PROJECT THE WORLD TRADE CENTER | TITLE EXTERIOR WALL-DAMPER CONN. REPAIR-FL 7&9 | DATE 8/20/69

19-AB-958

Max. reaming of slots Detail 1

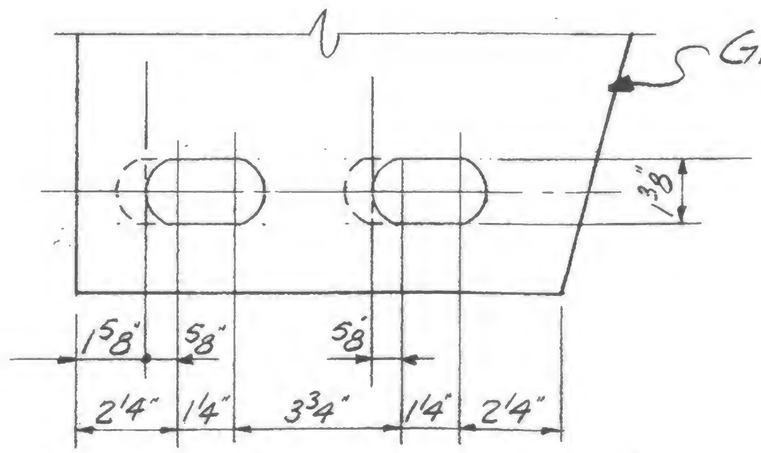
NOTES:
1. Bolt holes may be reamed to accomodate mis-matched holes providing that edge distances are maintained as shown in Detail 1 ℄2.
2. Were edge distances cannot be maintained Contractor may rectify the deficiency by plug welding and by re-reaming.
